Torque Tube Pins - options for improvement

Reason for Change

Option 3 Replace the straight pins TP14C and TP14D by AN486 taper pins

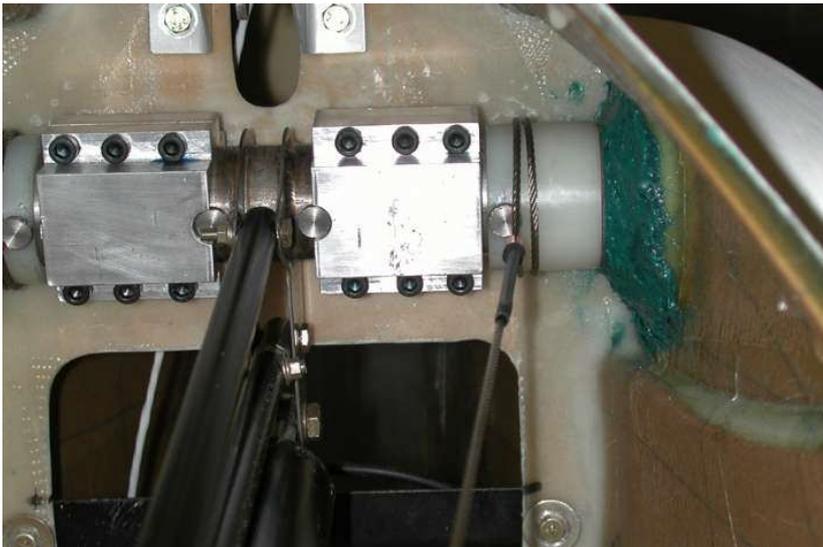
This option has been applied to a small number of aircraft. I am not aware of any reported wear after such an installation. The disadvantages of this installation are:-

- a) The bearing surface is not significantly increased.
- b) The required reaming is difficult for the untrained builder.
- c) A radial load is applied to the bearing surface. This may increase wear.
- d) With imperfect reaming a crushing load can be applied distorting the tube.
- e) With the available taper pins lengths a spacer is needed under the nut. This needs a saddle shaped surface to distribute the loads to the tube. In one aircraft the spacer has necessitated the cutting of additional hole in the adjacent bulkhead.

- f) The recommendation is that the head of a taper pin should extend $1/16^{\text{th}}$ inch above the pinned material. While this is adequate in solid material, in tubular material with a significantly curved surface there is an increased risk of the taper pin being pulled through the hole.
